Service Advisory

Product Line: ATV

Advisoy No: SAA201

Subject: Manual Rear Brake Switch Plunger/
Brake Switch Stop

Fig. 1

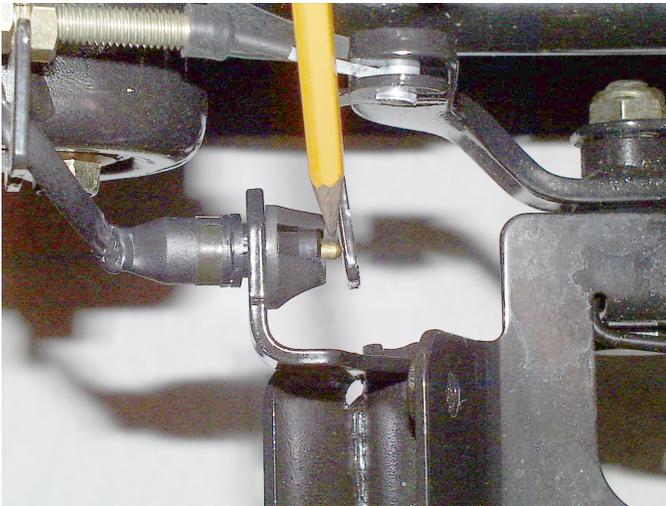
It has been determined that while the brake pedal is in the rest position, there may be insufficient clearance between the brake switch stop and the manual rear brake switch plunger on affected models. In some cases, this condition will cause the switch plunger to bottom out. If the switch plunger is bottomed out while the brake is in the rest position, a short in the ignition switch circuit may occur resulting in a blown ignition switch fuse.

■ **NOTE:** When the brake pedal is in the rest position, the switch plunger must be exposed a minimum of 3.175 mm (1/8 in.). See Fig. 1.

Bend the brake stop switch tab forward approximately 3.175 mm (1/8 in.) to prevent the brake switch plunger from bottoming out.

Fig. 1

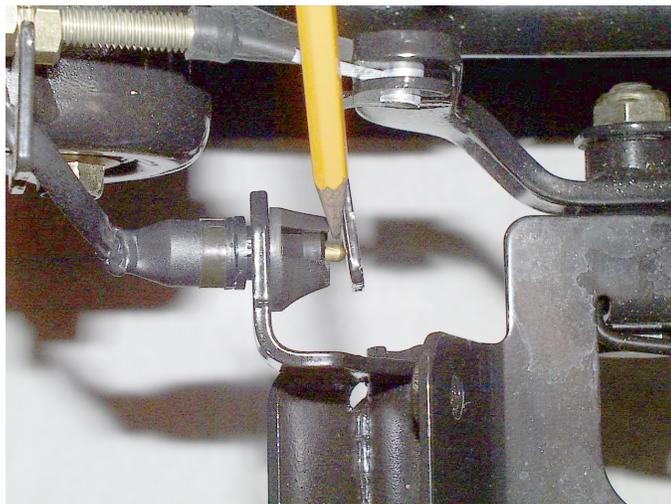
Il a été déterminé que lorsque la pédale de freins est en arrêt, il peut y avoir un dégagement insuffisant entre l'interrupteur d'arrêt de freins et le plongeur de l'interrupteur de frein manuel arrière sur les modèles concernés. Si le plongeur s'enfonce alors que le frein est en position d'arrêt, un court-circuit dans l'interrupteur pourrait se produire et ainsi causer une interruption du fusible de l'interrupteur d'allumage.

■ **REMARQUE:** Lorsque la pédale de freins est en arrêt, le plongeur de l'interrupteur doit être exposé au moins à 3,175 mm (1/8 po). Voyez la fig.1

Pliez l'onglet de l'interrupteur d'arrêt de freins vers l'avant à approximativement 3,175 mm (1/8 po) afin de prévenir le plongeur d'arrêt de freins à s'enfoncer.
